AMENDMENT OF SOLICITATION/MODIFICATION OF CONTRACT				1. CONTRACT ID CODE <div style="text-align: center;">J</div>		PAGE OF PAGES <div style="text-align: center;">1 9</div>

Amendment No. 5

AMENDMENT NO. 5 TO SPECIFICATIONS FOR REVITALIZE BARRACKS USMA PREPARATORY
SCHOOL BUILDINGS 1204 & 1205, FORT MONMOUTH, EATONTOWN, NEW JERSEY

SKETCH: STRUCTURAL STEEL
(SECOND AND THIRD FLOOR
- REFERENCE DRAWING A-36)

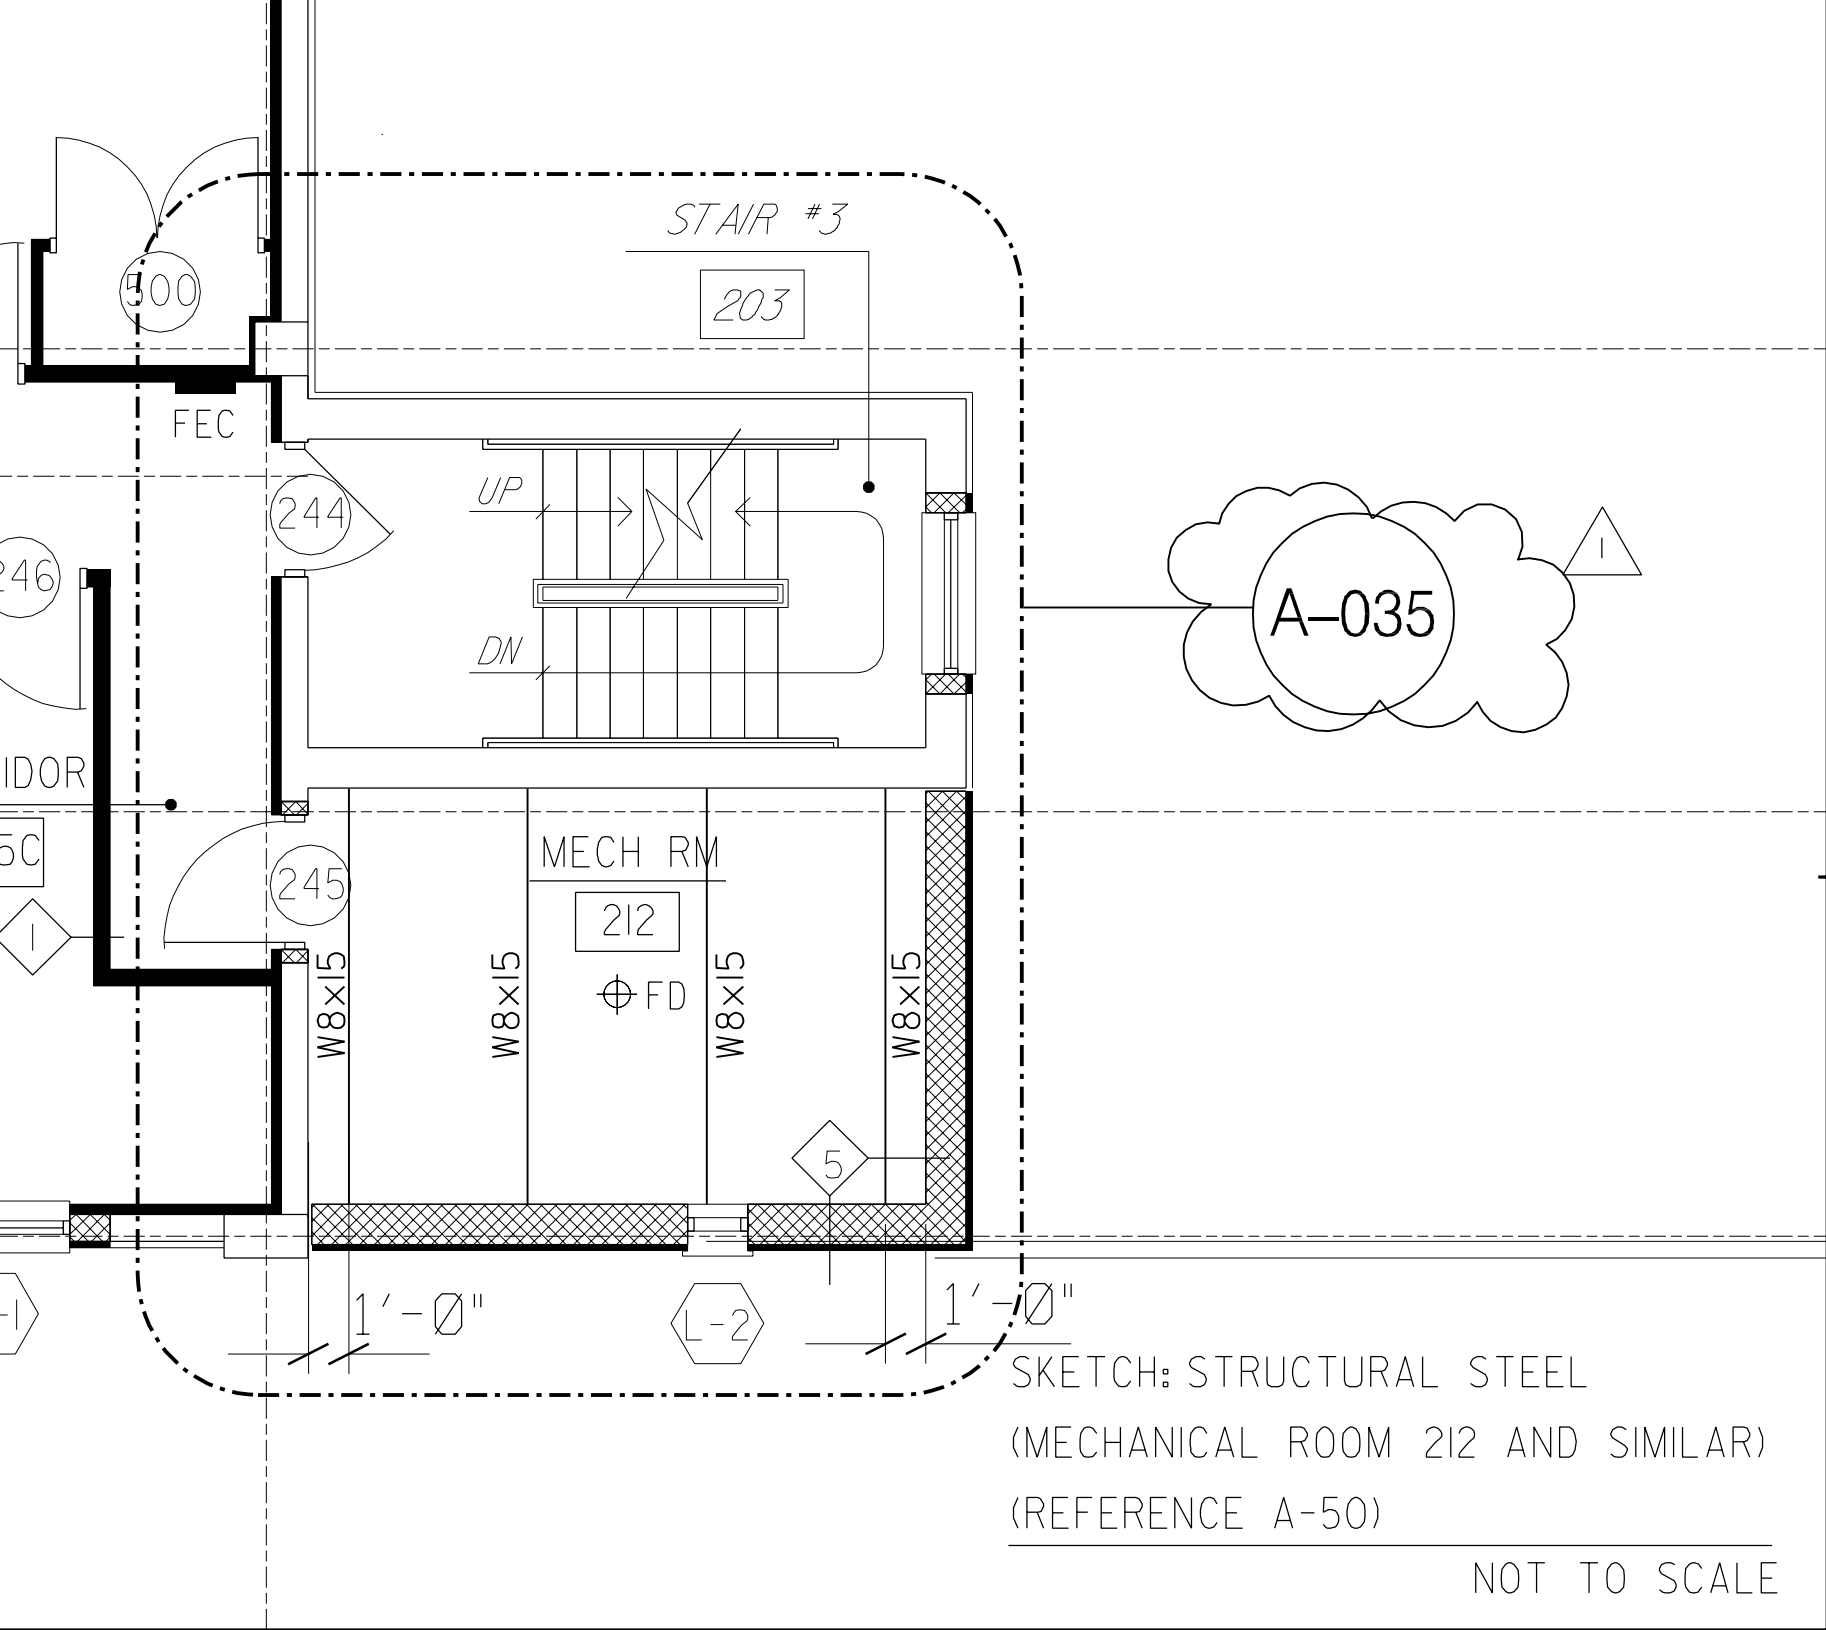
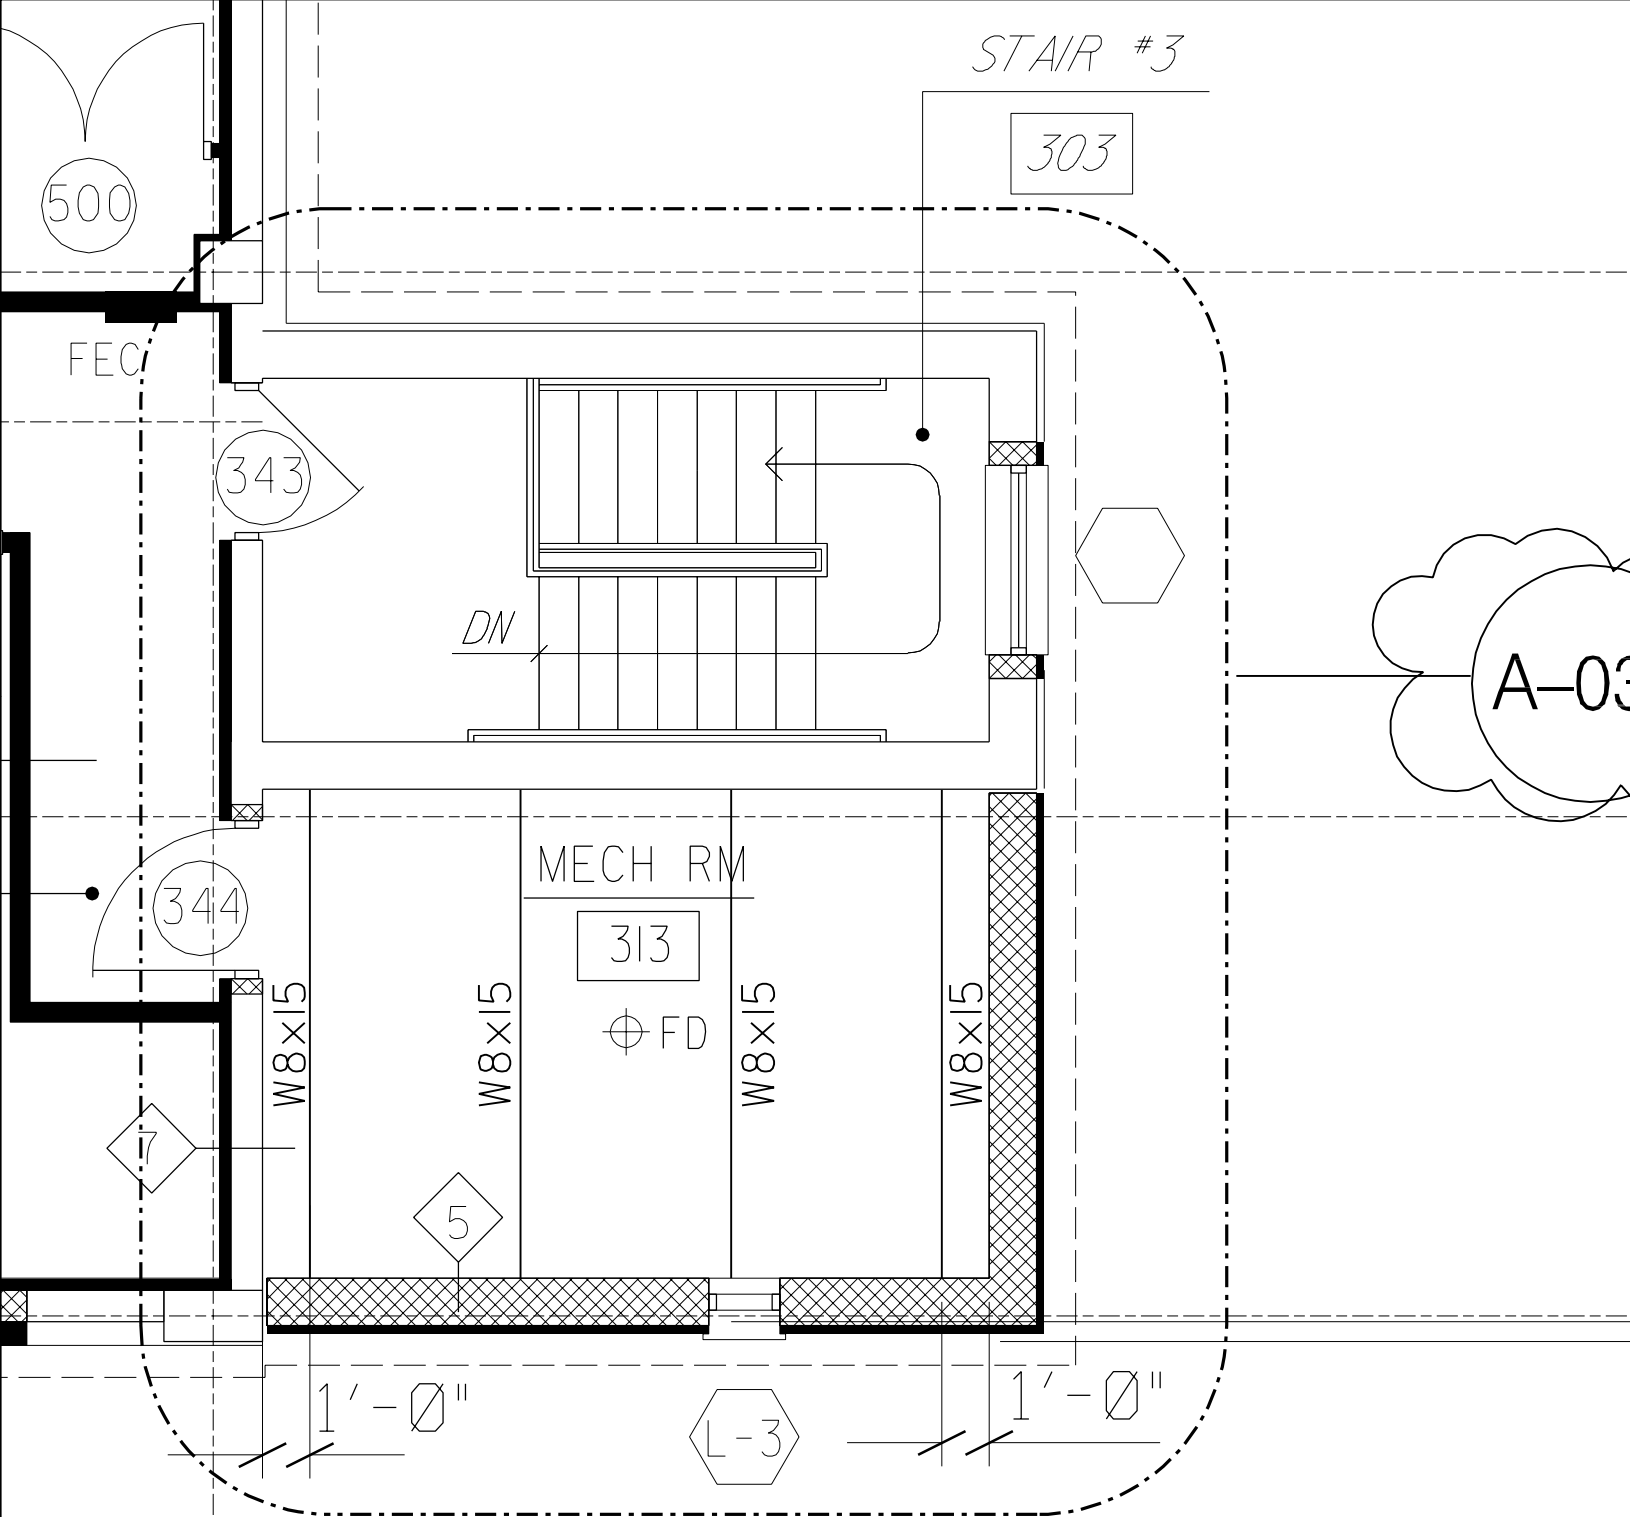
12. Q: What are the structural steel sizes of the beams Supporting the new Stairway Floor Slabs?

A: See sketch in this Amendment.
